SUBJECT: COMANCHE PEAK NUCLEAR POWER PLANT, UNITS 3 AND 4
DOCKET NUMBERS 52-034 AND 52-035
ENVIRONMENTAL REPORT REVISION 3, UPDATE TRACKING REPORT REVISION 0
(CHAPTERS 2, 3, 4, AND 6)

**Comanche Peak Nuclear Power Plant, Units 3 & 4
COL Application**

Environmental Report Revision 3

Update Tracking Report

Figure 2.1-1 Site Plot Plan

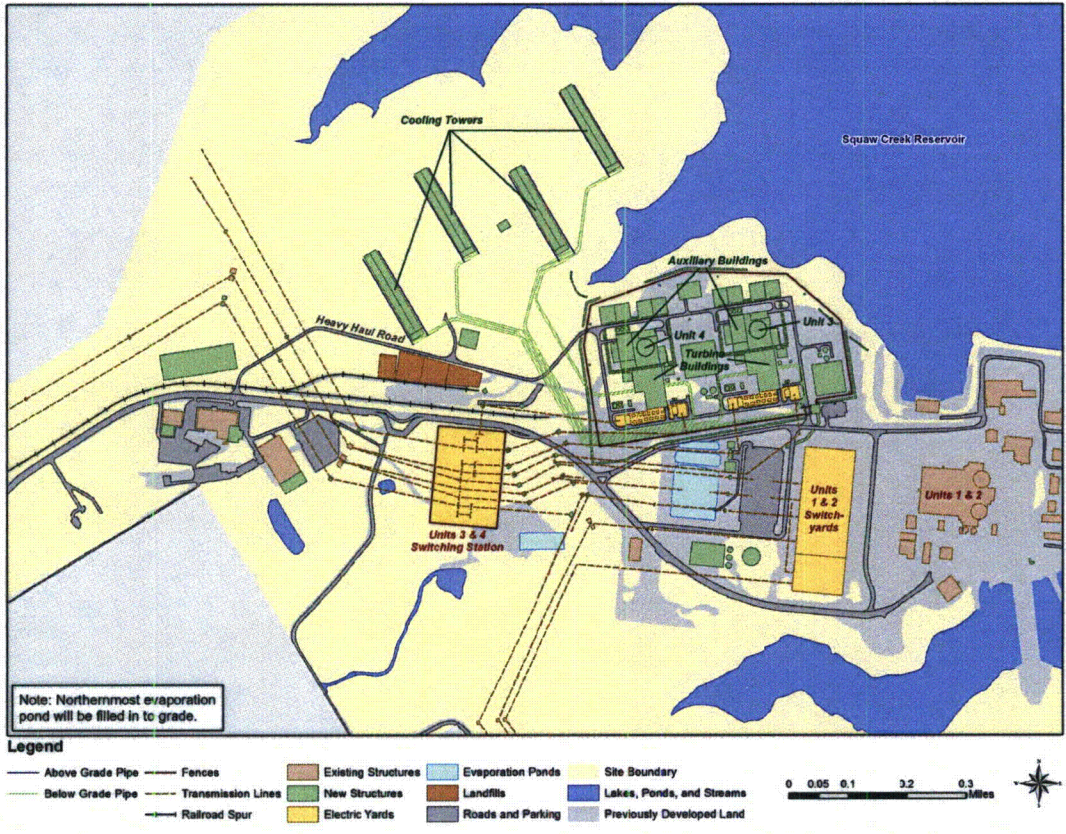
Change ID No.	Section	ER Rev. 3 Page*	Reason for change	Change Summary	Rev. of ER T/R
CTS-01520	Figure 2.1-1 Figure 2.3-26 Figure 2.3-27	-	To reflect plant layout changes as described in Luminant ISCP Letter ML12268A41	Updated to reflect standard plant and site-specific layout changes	0

Figure 3.1-1 Site Plan

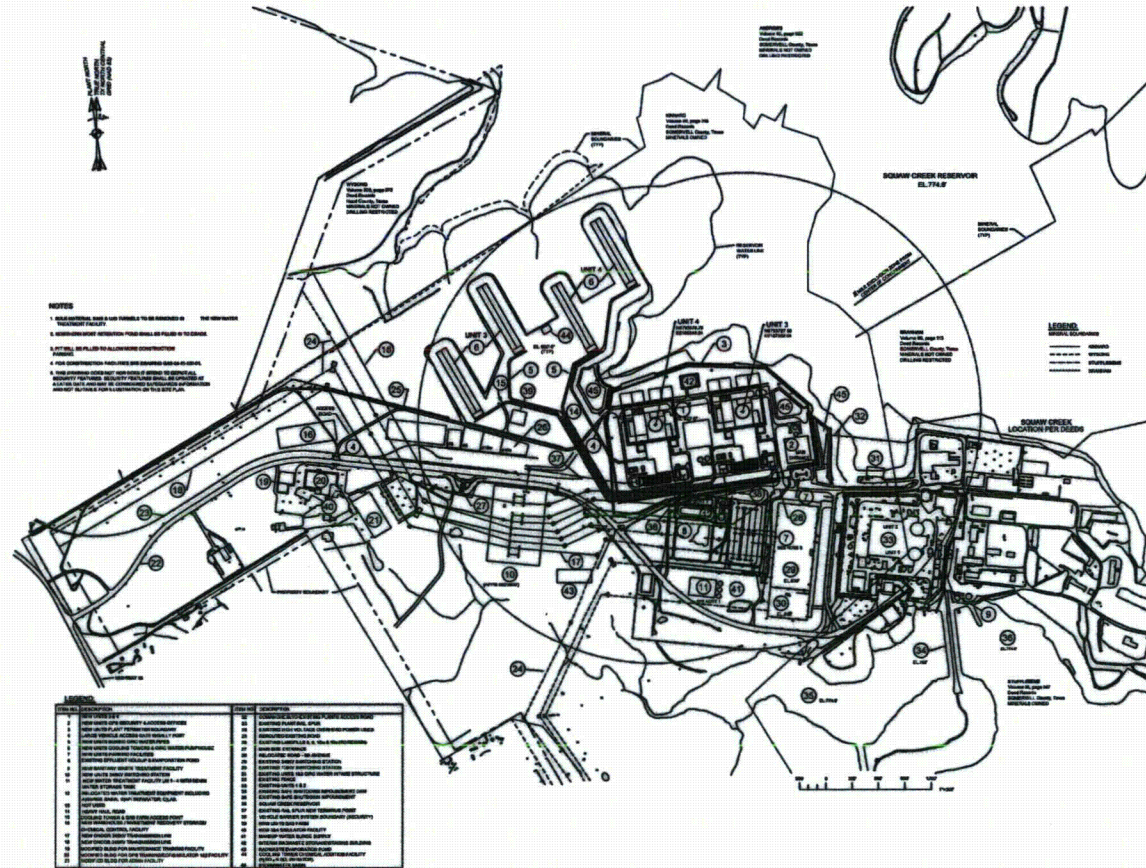
Change ID No.	Section	ER Rev. 3 Page*	Reason for change	Change Summary	Rev. of ER T/R
CTS-01520	Figure 3.1-1 Figure 3.1-2 Figure 3.4-3	- - -	To reflect plant layout changes as described in Luminant ISCP Letter ML12268A41	Updated to reflect standard plant and site-specific layout changes. Also includes removal of meaningless cross-references and an updated legend.	0

Figure 4.1-1 Detailed Site Plot Plan with Construction Laydown Areas

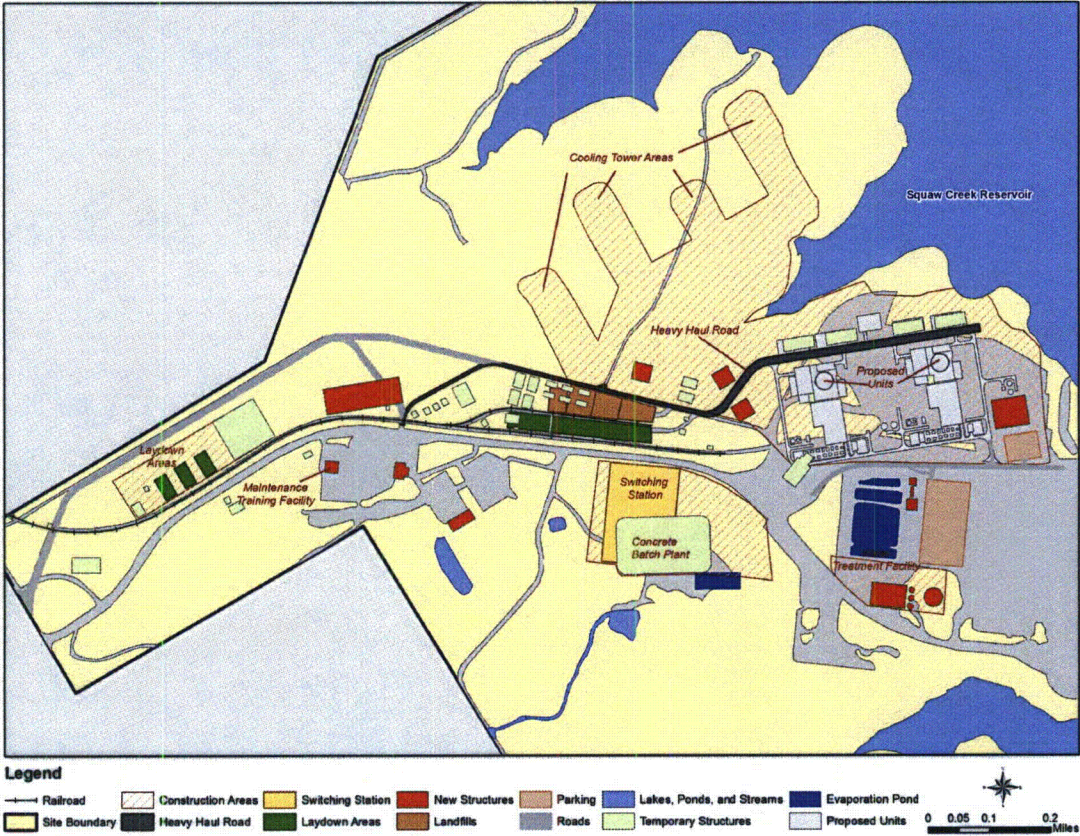
Change ID No.	Section	ER Rev. 3 Page*	Reason for change	Change Summary	Rev. of ER T/R
CTS-01520	Figure 4.1-1	-	To reflect plant layout changes as described in Luminant ISCP Letter ML12268A41	Updated to reflect standard plant and site-specific layout changes	0

Figure 6.3-1 CPNPP Monitoring Well and SCR Aquatic Monitoring Station Locations

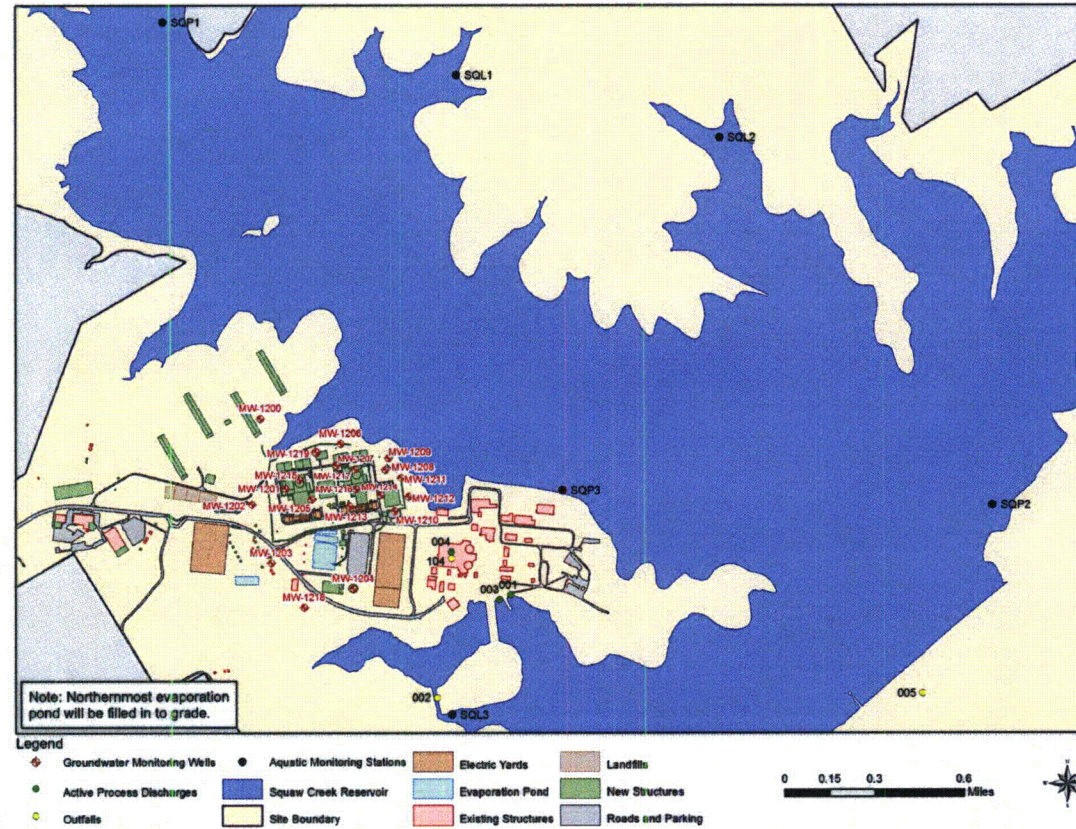
Change ID No.	Section	ER Rev. 3 Page*	Reason for change	Change Summary	Rev. of ER T/R
CTS-01520	Figure 6.3-1	-	To reflect plant layout changes as described in Luminant ISCP Letter ML12268A41	Updated to reflect standard plant and site-specific layout changes	0
